## Change Order #4 Las Milpas Road

Project: Las Milpas Road  
Contract: C-22-0094-09-06(ARPA 22-1-122-109)  
Limits: McColl Rd (FM 3062) to 10<sup>th</sup> Street (FM 336)

Description: Change Order No. 4 extends a proposed 12' x 8' concrete box drainage culvert 24 Ft to the north to protect an exposed gas line.

LAS MILPAS ROAD SUMMARY SHEET OF ESTIMATED QUANTITIES

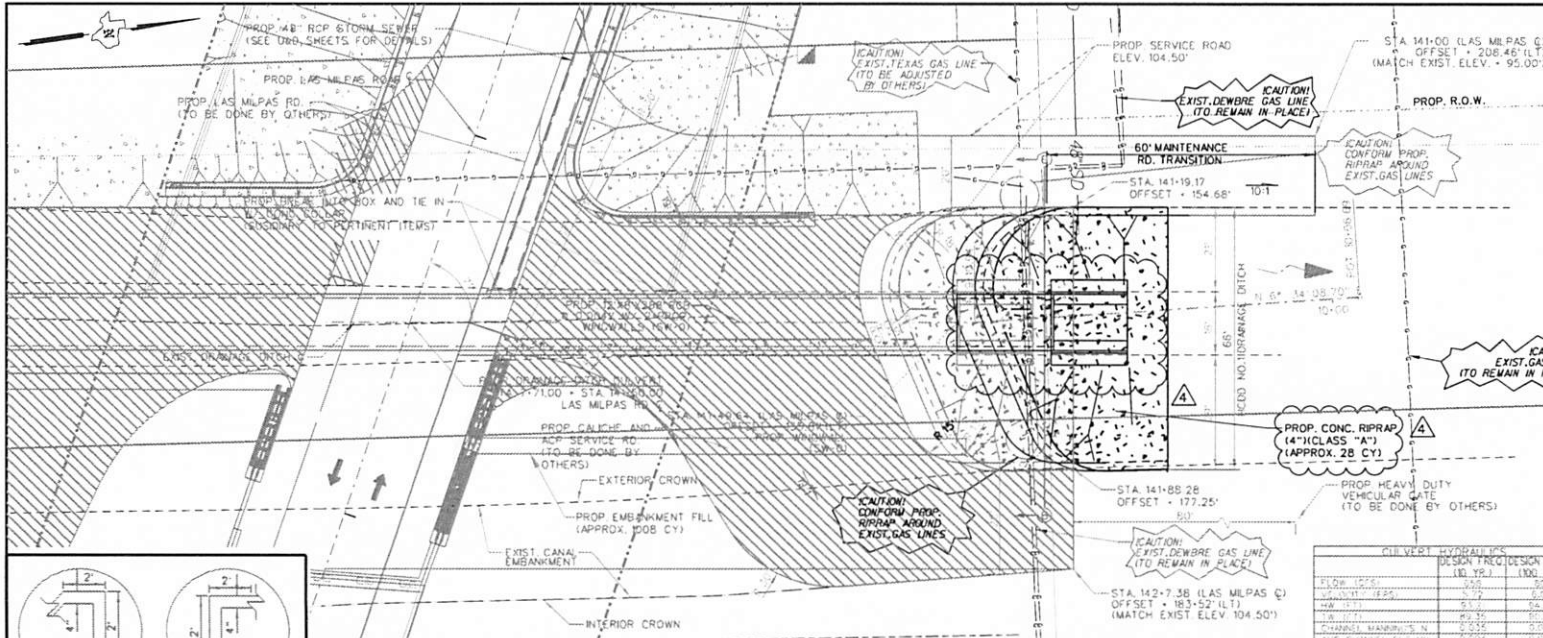
CO#4 - Extend a 12"x8" box culvert 24ft to protect a 2.5" high pressure gas line in conflict with the culvert opening.

LAS MILPAS ROAD  
 CULVERT 1LAYOUT  
 STA. 141-50

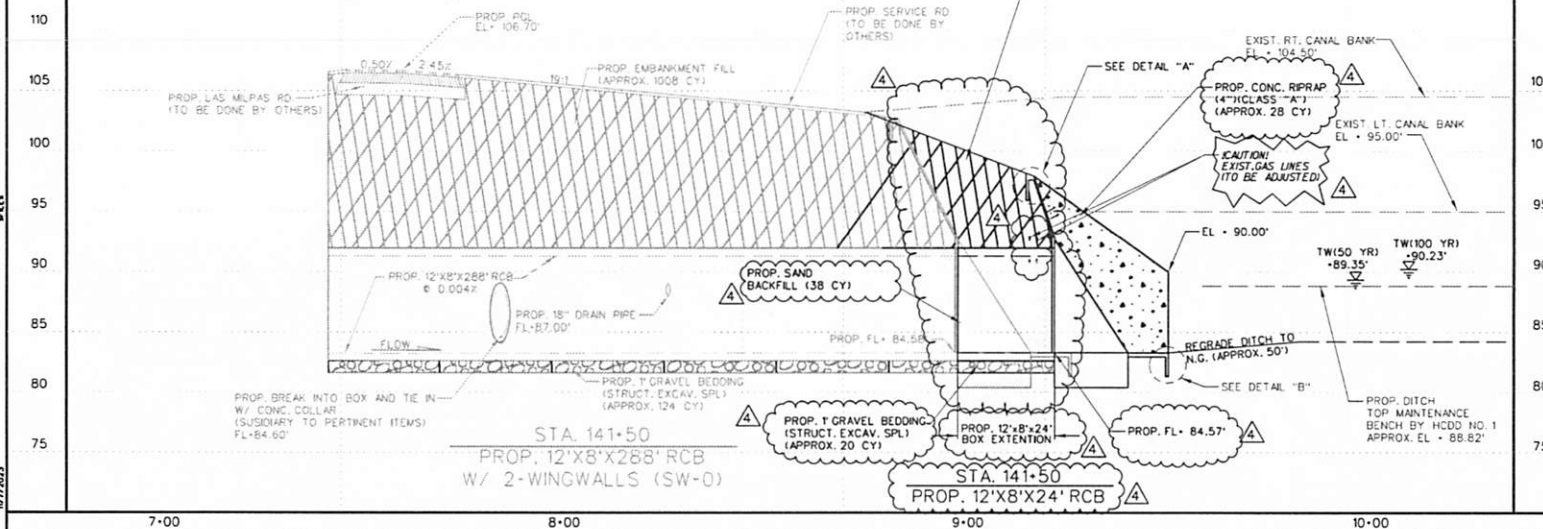
- SEE ALIGNMENT DATA SHEET FOR PROP. CENTERLINE DATA.
  - CULVERT WAS ANALYZED USING FEDERAL HIGHWAY ADMINISTRATIONS, FHWA "HY-B" SOFTWARE.
- CO #4 - EXTEND THE 12'x8' BOX CULVERT 24 FT TO ADJUST AND COVER UP A HIGH PRESSURE GAS LINE IN DIRECT CONFLICT WITH THE OPENING.
